LiDAR Quality Assessment Report

KS_11County_2010

The remaining 11 counties are Lot 3 of KS-15 County delivery project. The 11 counties are donated data and were delivered along with partnership data. Three reports will be delivered for the 15 counties - One for Harvey Co. (lot 1), 1 for Lyon, Morris and Chase Cos. (lot 2) and 1 for the remaining 11 counties plus Dodge City and USFWS (lot 3).

KS_15County_2010

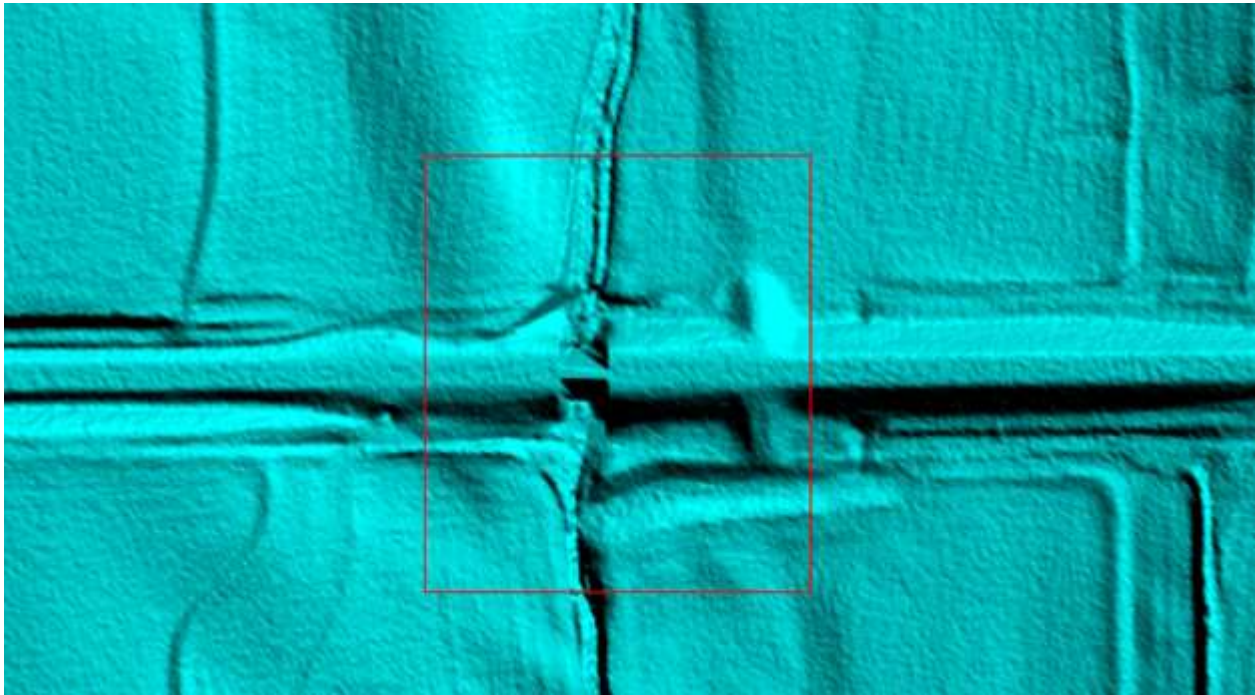
Bridge not completely removed. This is a representative image, there are 3 of these types of errors.

**Vendor corrected errors

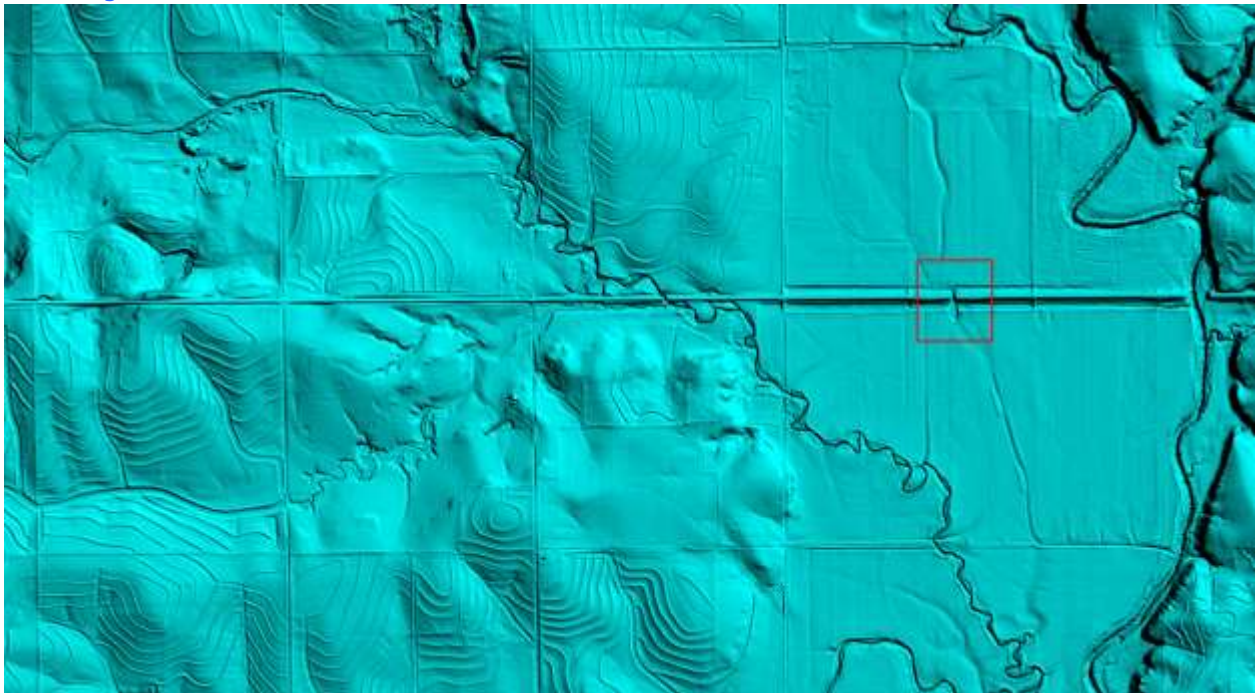
Area where a culvert has been removed. There are 17 errors. This is only a representative image.

**Vendor corrected errors

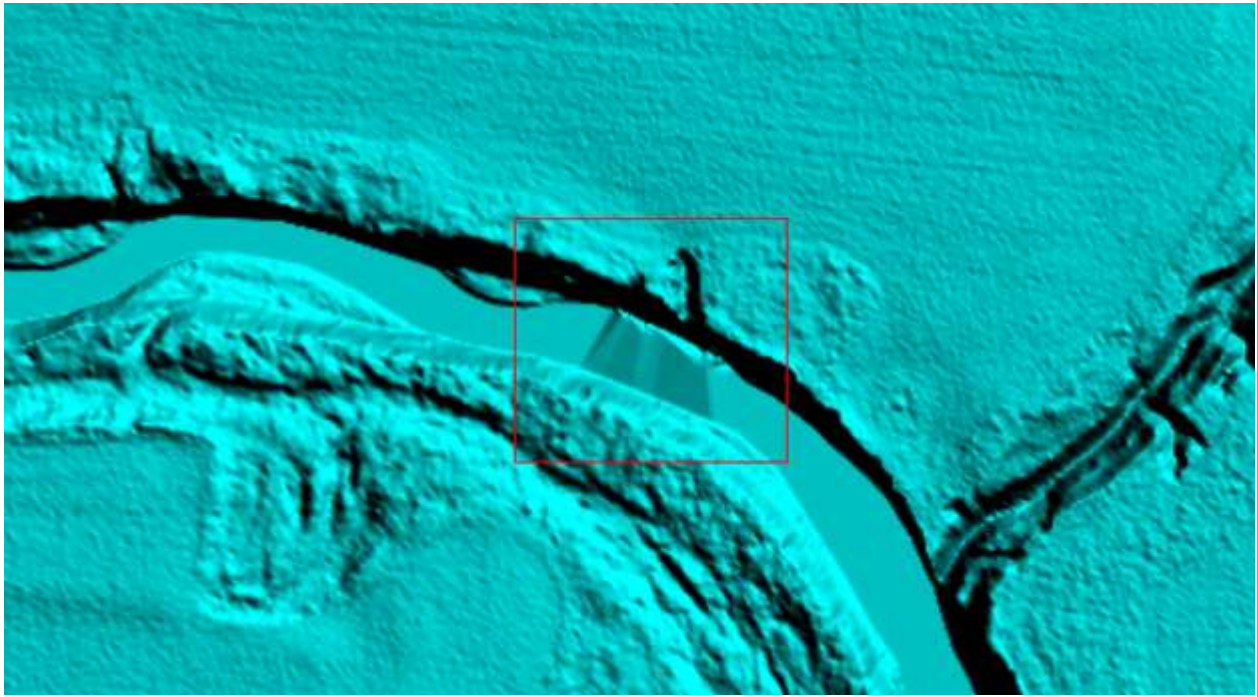
The shoreline along most of the reservoir above is elevated above the surrounding land. Location at 38° 23' 53.2916" N, 97° 07' 1.1953" W

**Vendor corrected errors

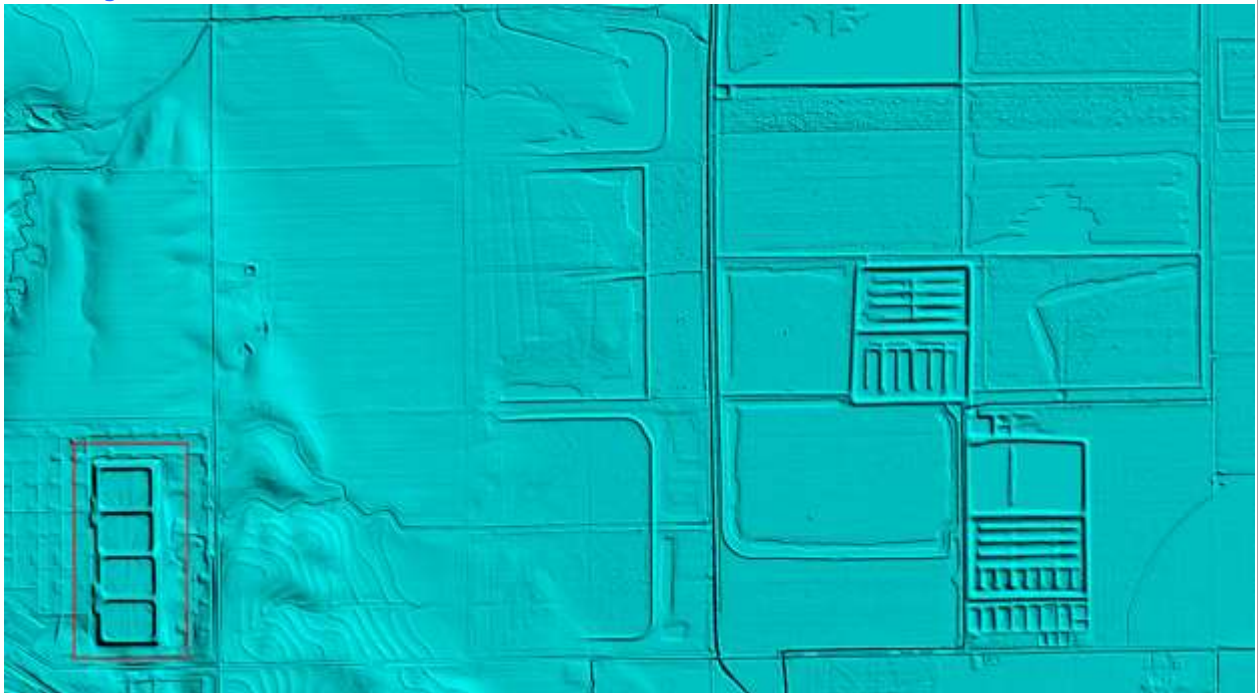
These need to be hydroflattened. The area is greater than 2 acres for each. Location at 38° 22' 24.3823" N, 97° 46' 52.0240" W

**Vendor corrected error

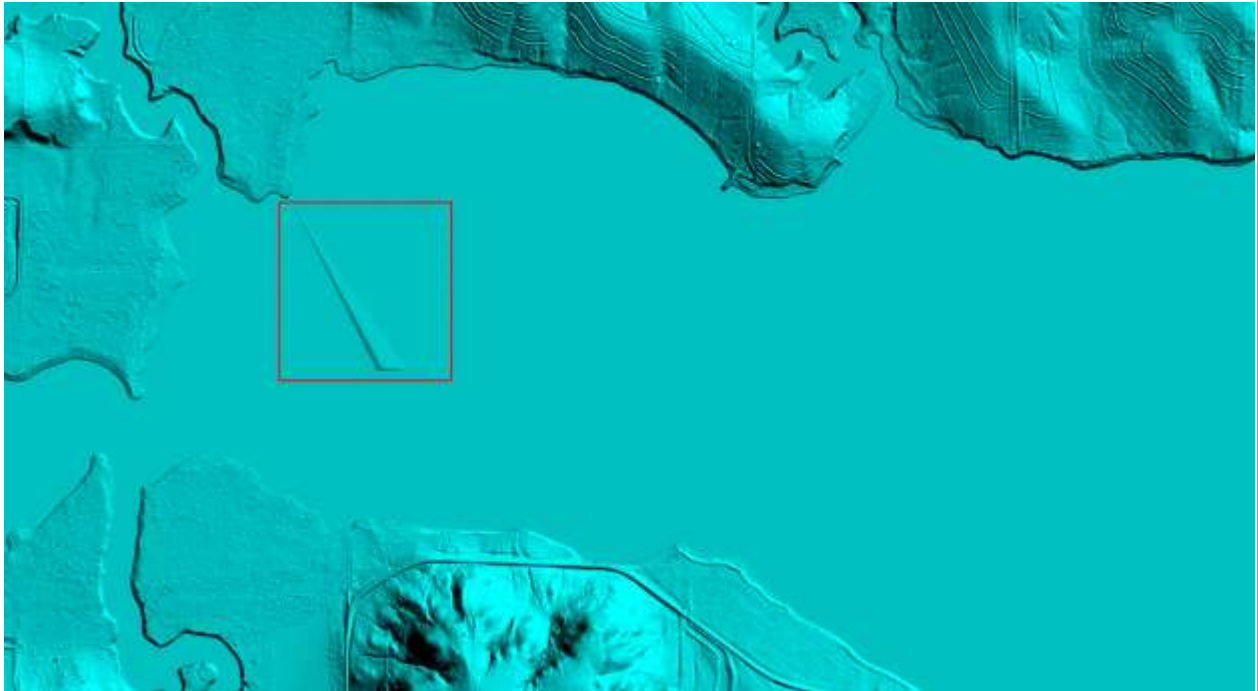
Tinning in the waterbodies. There are 3 errors of this type. This is only a representative image.

**Above error not corrected (Jewell County). Vendor fixed other 2 errors

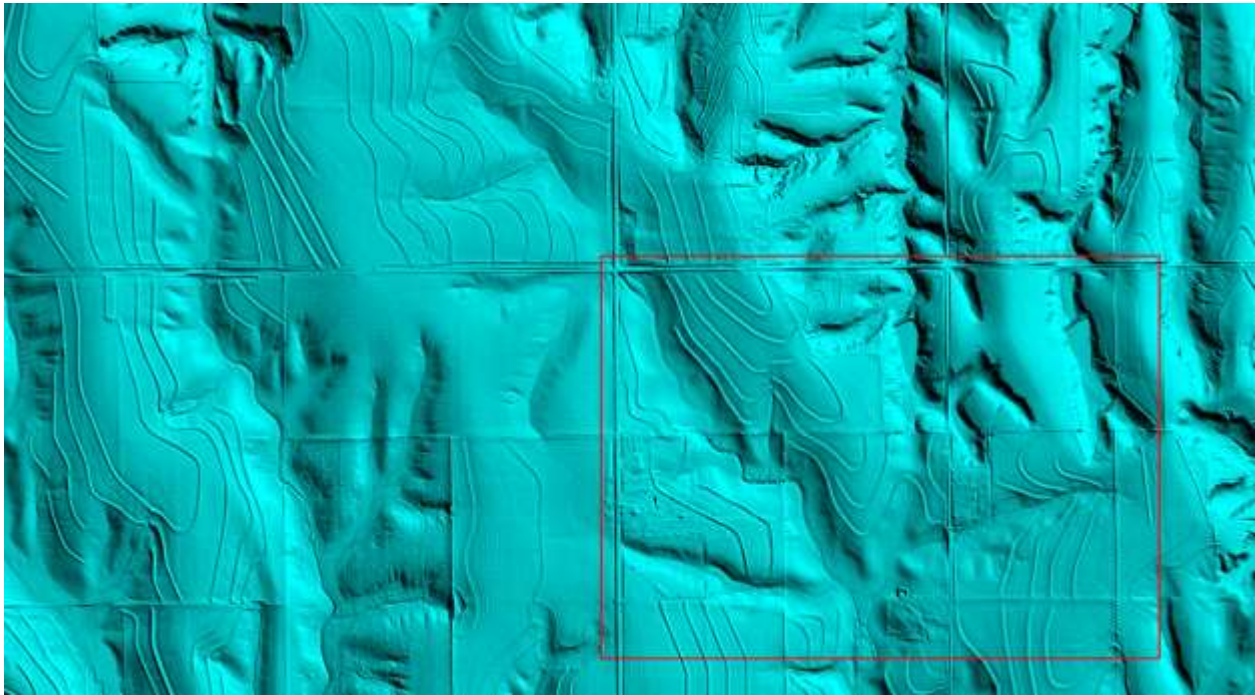
Anomalous error in which the DEM has lines and gouges in the DEM. Location at 39° 59' 0.3406" N, 98° 21' 50.1239" W

**Vendor did not correct error (Jewell County)

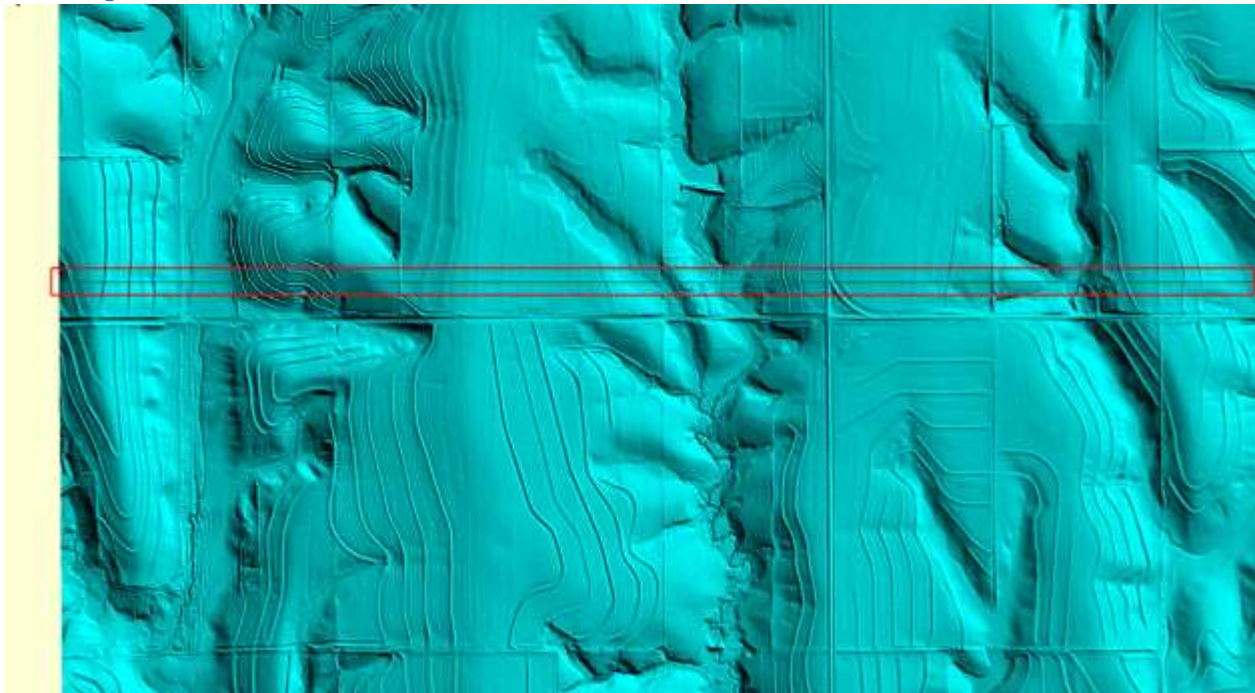
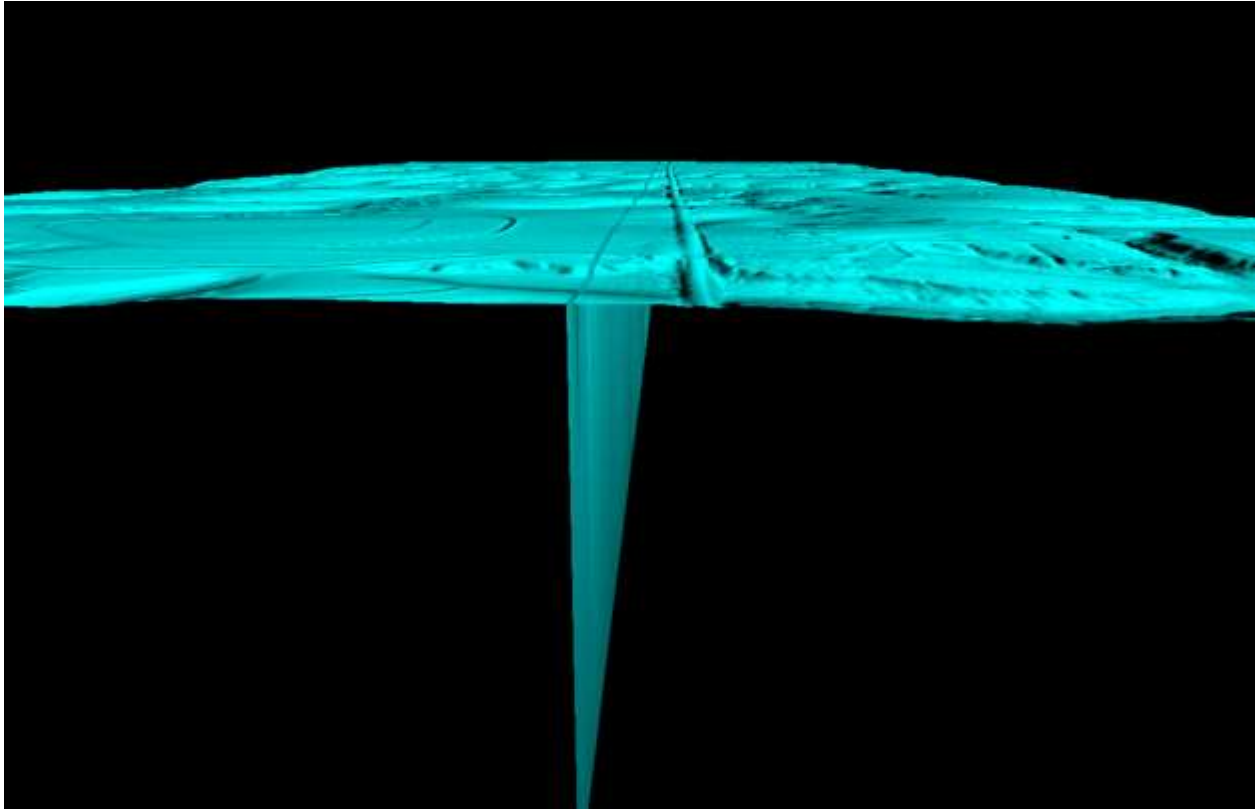
Anomalous error #2. There is a gap in the data that results in a 300+ meter drop on either side of the DEM. This error box is only a small section of the entire error which stretches across the length of the data. Location at 39° 58' 26.5944" N, 98° 29' 59.9340" W

3D view of the above error.

**Vendor did not fix correct error (Jewell County)

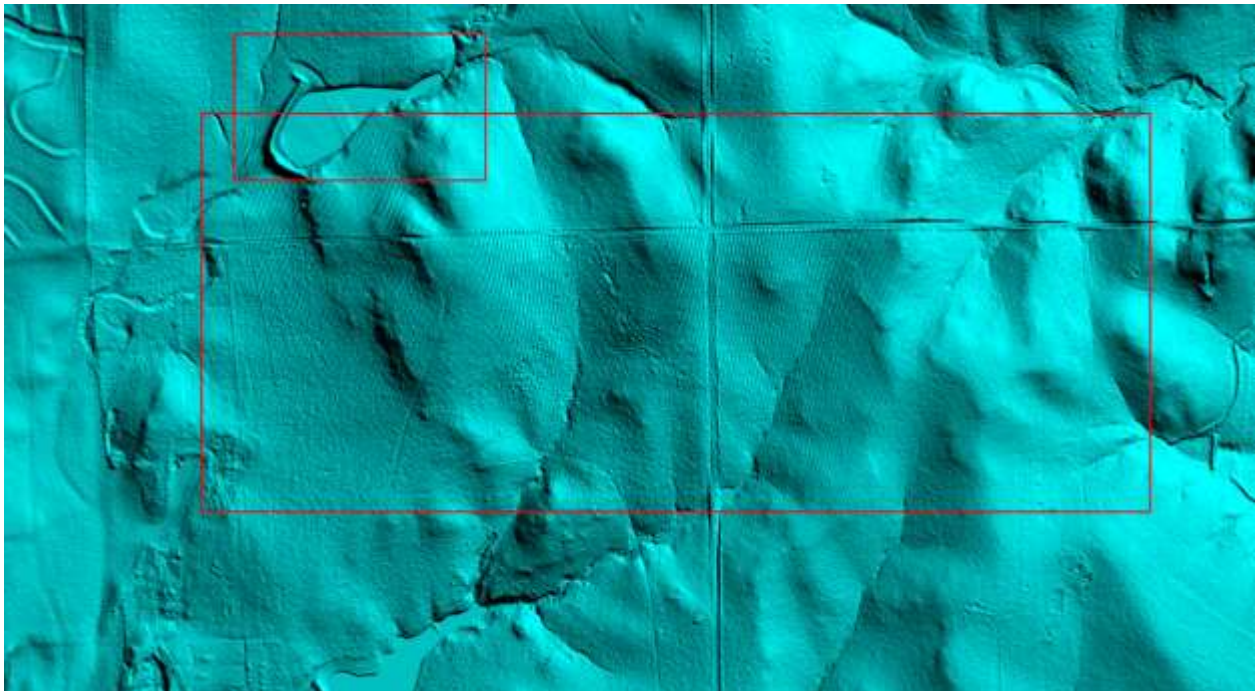
Anomalous error in which there are lines in a rectangular pattern in the DEM.
Location at 39° 11' 20.7963" N, 97° 55' 50.4278" W

**Vendor corrected error

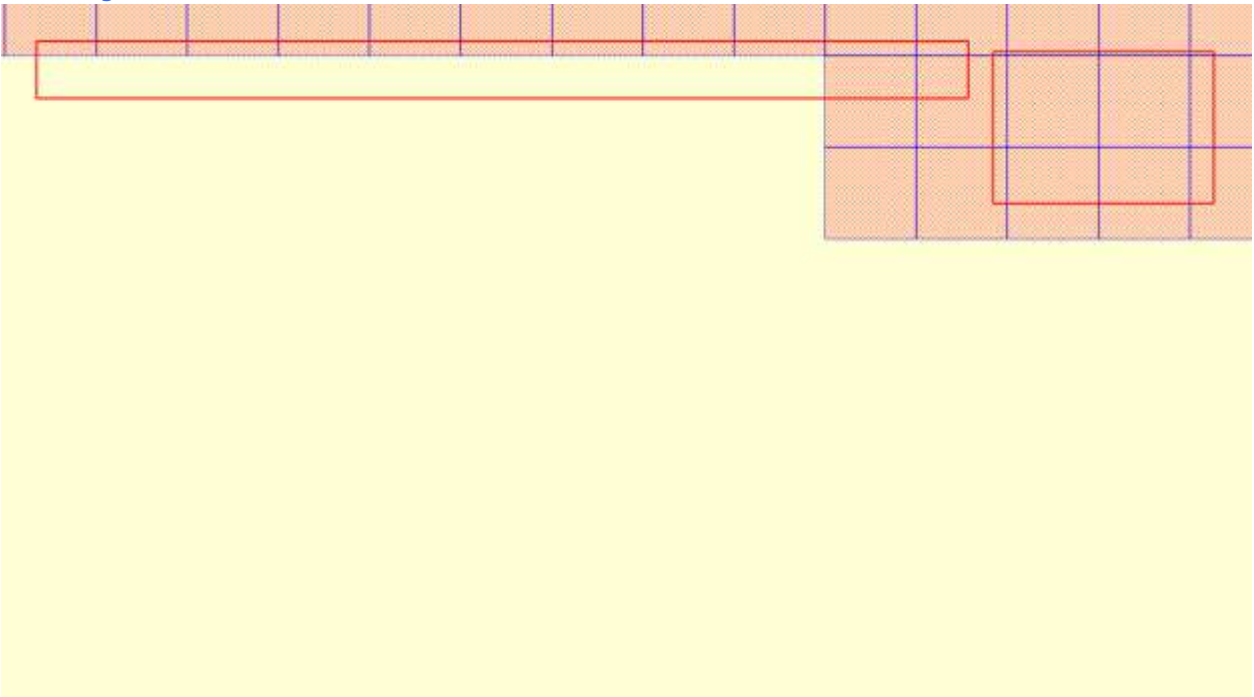
Two areas in which there are rectangular features that are raised above the land. Location at 38° 08' 36.4732" N, 97° 08' 11.0977" W

**Vendor corrected error
